CONTRACT CHANGE ORDER NO. 178
SHEET 3 OF 6

MARK	DATE	REVISIONS	BY	CH'D	CCO#
0	03/28/11	SKYWAY BIKEPATH TRAVELER COMPLETION WORK	TH	JD	178

SAN FRANCISCO OAKLAND BAY BRIDGE
EAST SPAN SEISMIC SAFETY PROJECT

SKYWAY CLEANUP ITEMS

ADDITIONAL BOLT INSTALLATION

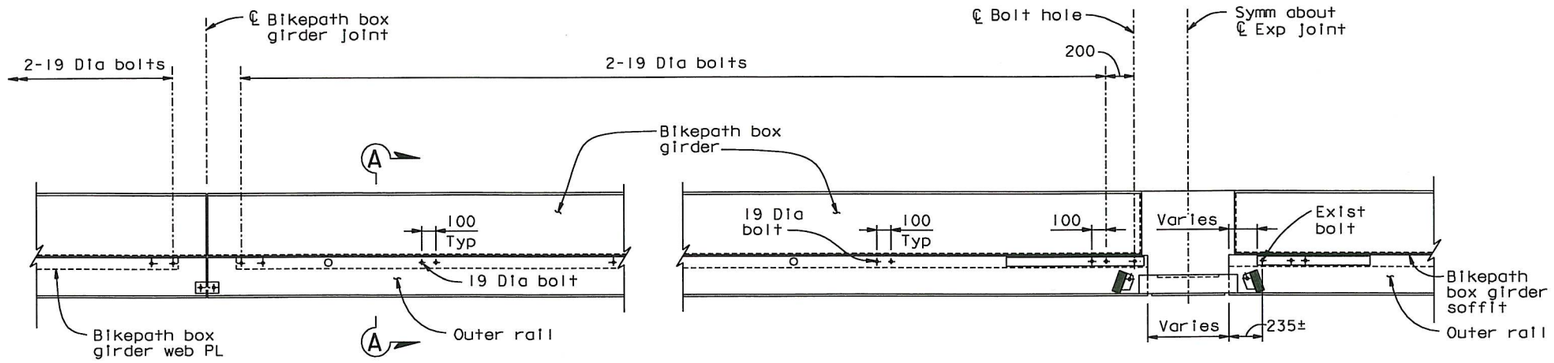
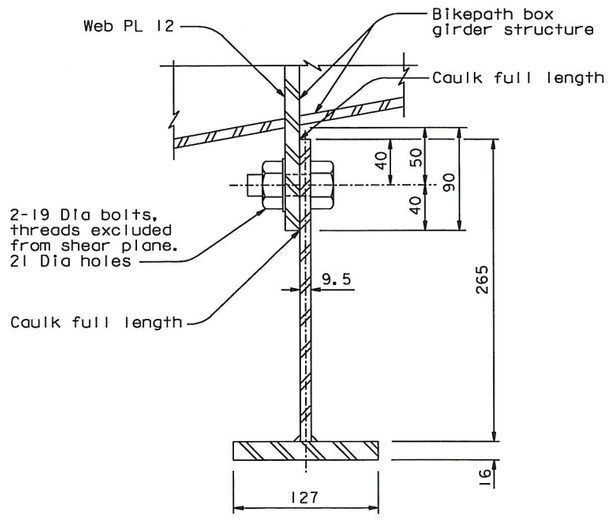
1. Install additional 19 Dia bolt 100 mm from existing 19 Dia bolt.
2. Caulk outer rail to Web PL 12 at top and bottom.

BELVEDERE BEAM REMOVAL

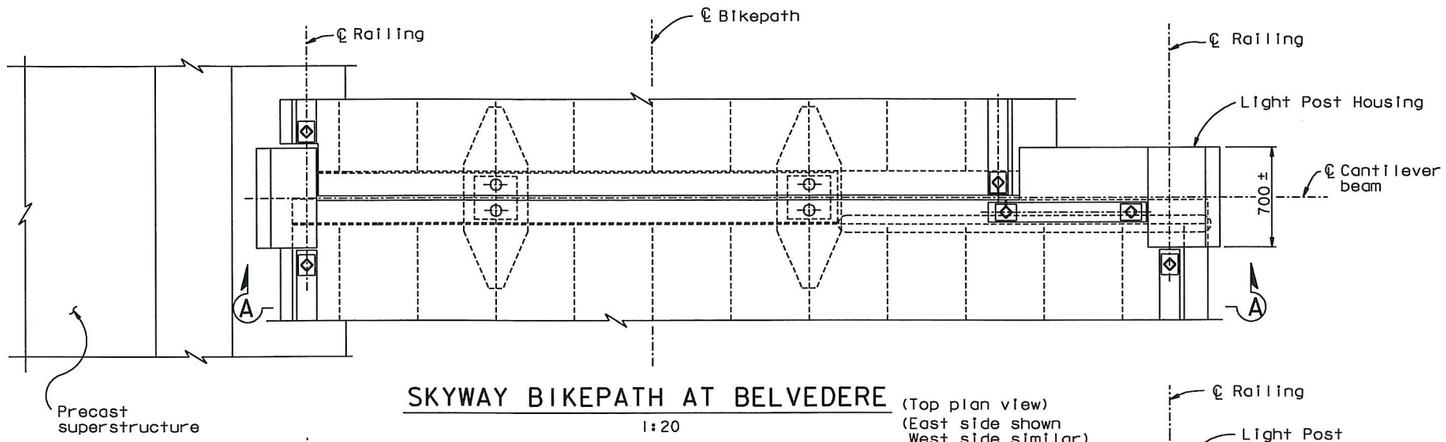
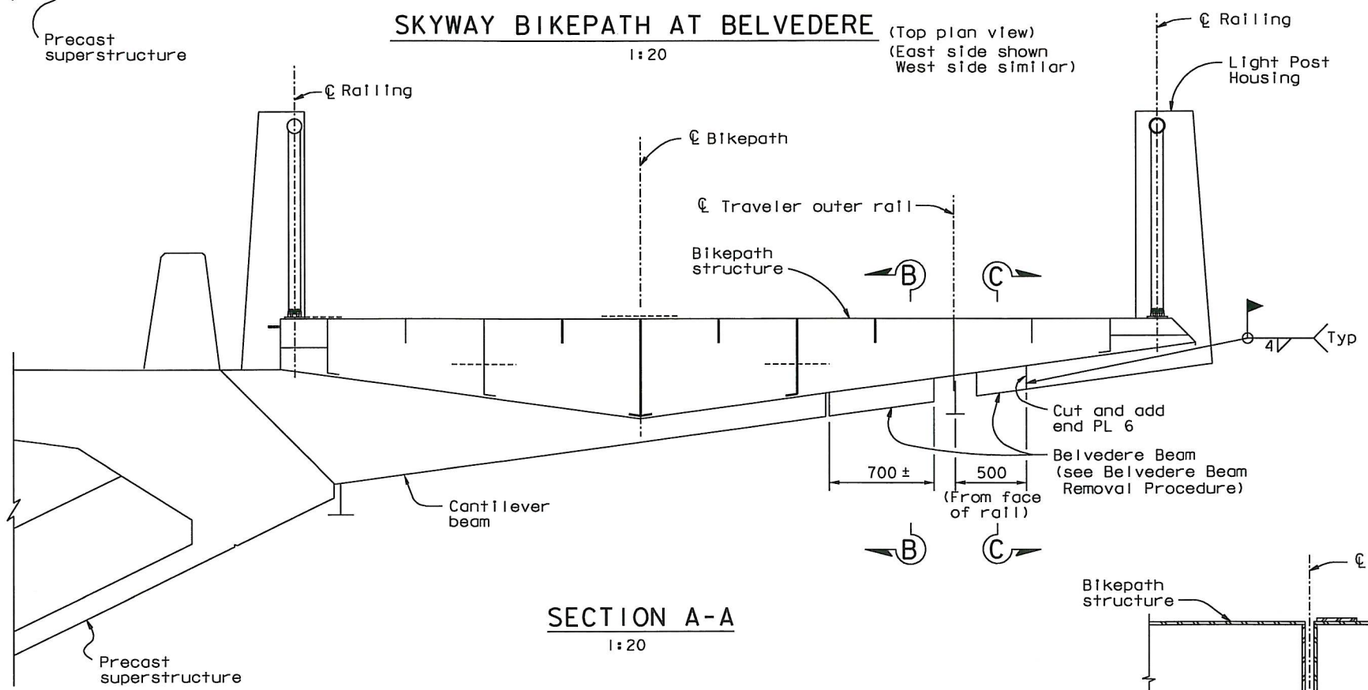
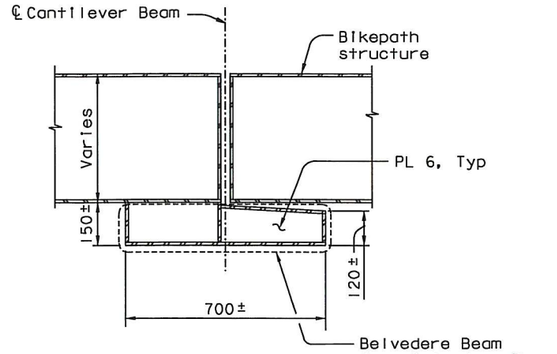
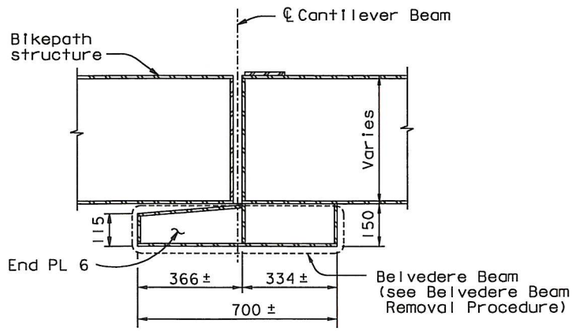
1. Install protective cover on traveler rail.
2. Remove portions of Belvedere Beam. Cut line shall be 10 mm away from the permanent structure or as otherwise approved by the Engineer.
3. Removal of steel shall not damage the remainder of the steel structure materials.
4. Steel surface shall be ground flush and damaged areas shall be repaired in accordance with the requirements of ANSI/AASHTO/AWS D1.5.
5. Cover opening in Belvedere Beam with an end PL 6. The edges of beam shall be squared, plumb and ground smooth prior to welding end PL.
6. Areas with damaged paint or with no paint shall be cleaned and painted.

1. 2 existing Belvedere Beams shall be removed at Pier 4E, 6E, 8E, 10E and 12E.
2. Contractor shall field verify all dimensions.

LADDER REMOVAL

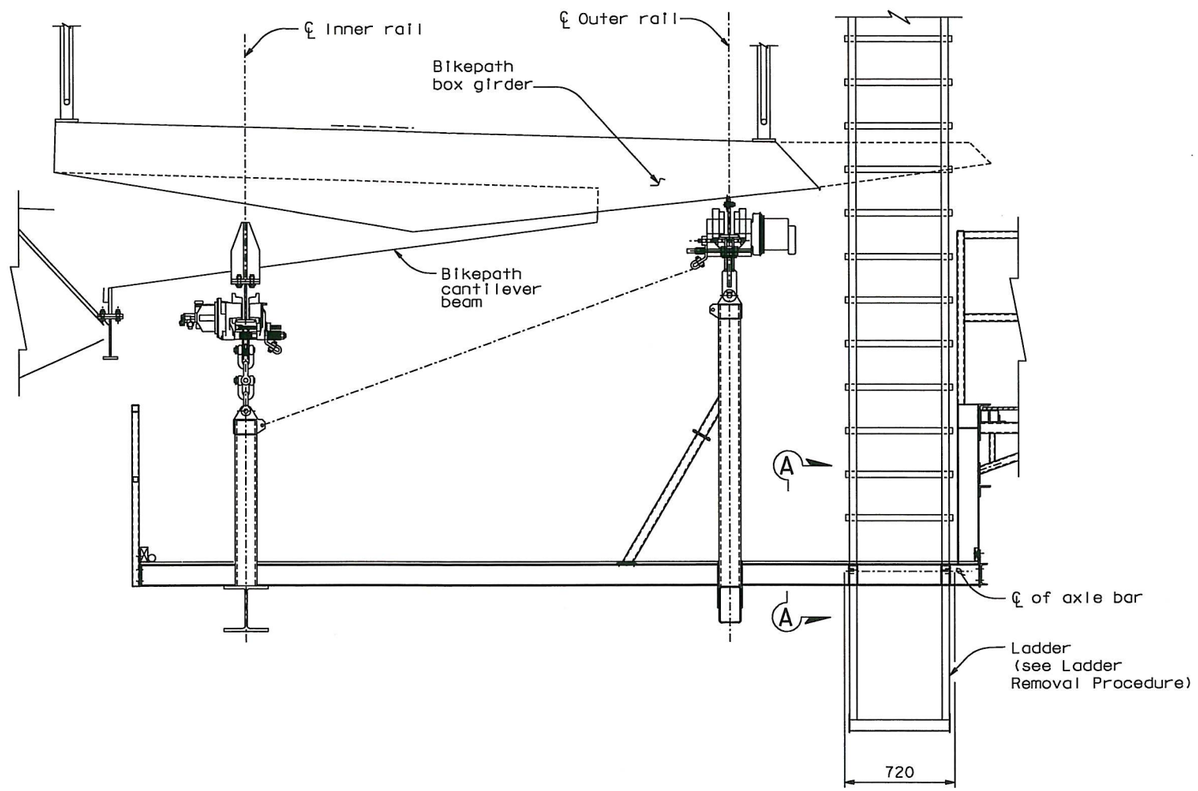
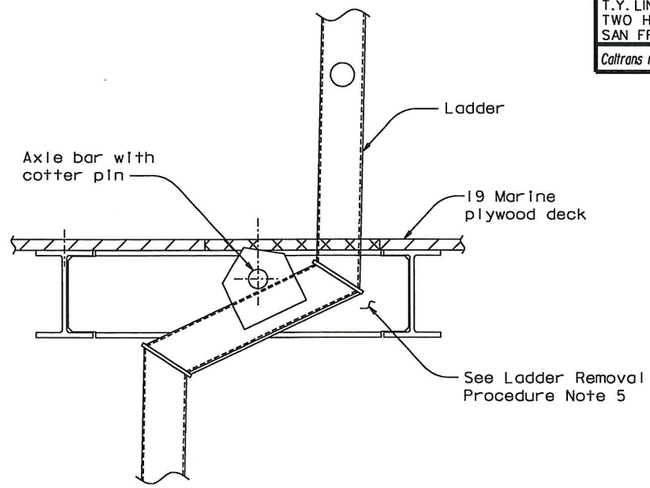
1. Remove cotter pin and axle bar.
2. Remove existing fold down ladder and all of its attached components.
3. Plywood decking and toeboards shall be replaced in their entirety. Plywood decking shall conform to or exceed the requirements of U.S. Product Standard PS-1-9S for APA Structural I AB Marine Grade. Plywood shall be pressure treated. Plywood decking shall be painted on all sides.

Wooden toeboards shall be pressure treated S4S Douglas Fir. Toeboards shall be painted on all sides.
4. Plywood decking shall be attached using blind rivets. Blind rivets shall be stainless steel, 4.8 mm diameter and shall be installed at 305 mm maximum on center.
5. Areas with damaged paint or with no paint shall be cleaned and painted. Any damage to the galvanized surfaces shall be repaired with zinc rich primer. Galvanized surfaces shall be finish painted.

SKYWAY CLEANUP ITEMS
TRAVELER DECKING REPLACEMENT

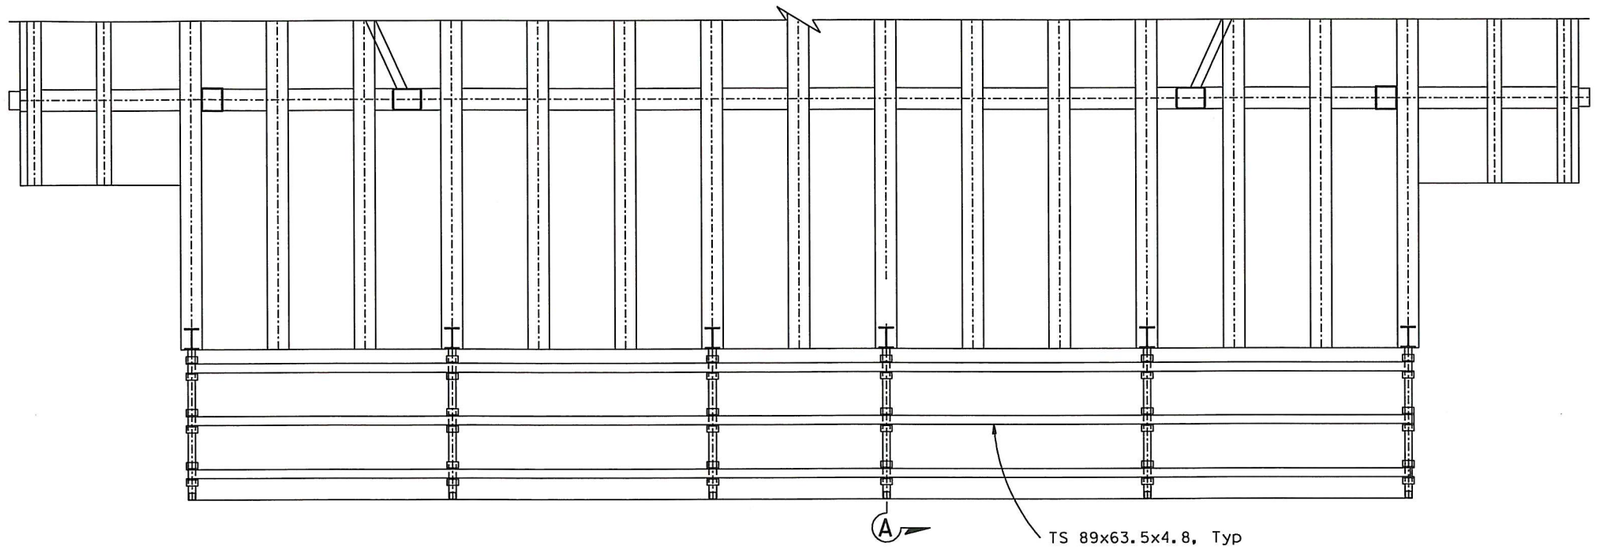
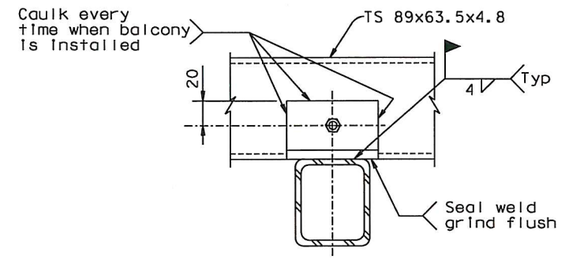
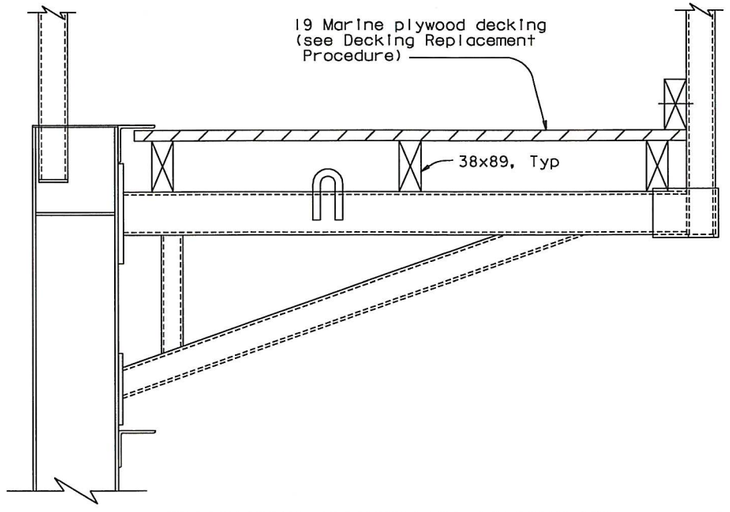
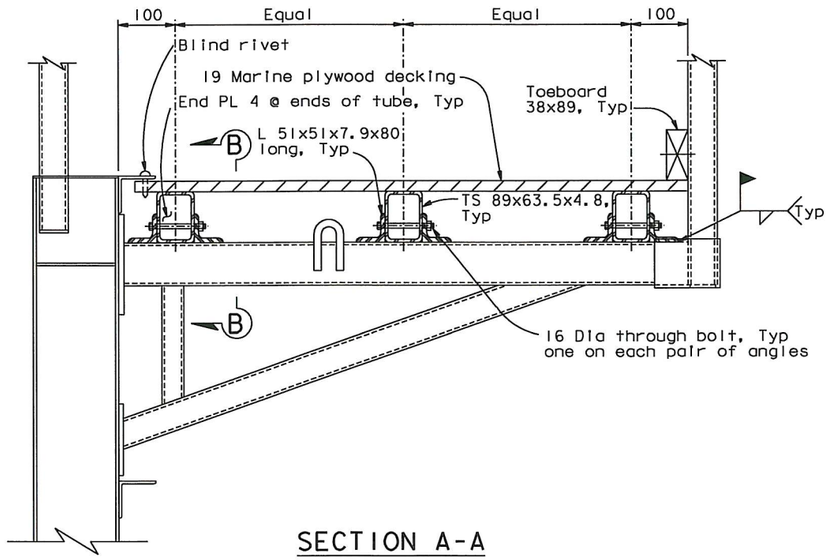
1. Remove Marine plywood and 38x89 lumber.
2. Install structural angles and tubing. Tube sections to be ASTM A500 Grade C or ASTM A300 Grade B with mill certificates satisfying Grade C Fy & Fu, subject to review and approval of the Engineer. Angles to be ASTM A572 Grade 42 or ASTM A709 Grade 345.

3. Bolts
   a) All bolts to be ASTM grade A325, unless noted otherwise
   b) Fabricator is to supply a nut and one hardened washer with each bolt unless noted otherwise.

c) All bolts, nuts, and washers are to be galvanized.
   d) All 16 Dia bolts shall be imperial (5/8 inch) size.
4. Install new plywood decking and toeboard. Plywood decking shall conform to or exceed the requirements of U.S. Product Standard PS-1-9S for APA Structural I AB Marine Grade. Plywood shall be pressure treated. Plywood decking shall be painted on all sides. Wooden toeboards shall be pressure treated S4S Douglas Fir. Toeboards shall be painted on all sides.

5. Plywood decking shall be attached using blind rivets. Blind rivets shall be stainless steel, 4.8 mm diameter and shall be installed at 305 mm maximum on center.

6. Areas with damaged paint or with no paint shall be cleaned and painted. Any damage to the galvanized surfaces shall be repaired with zinc rich primer. Galvanized surfaces shall be finish painted.
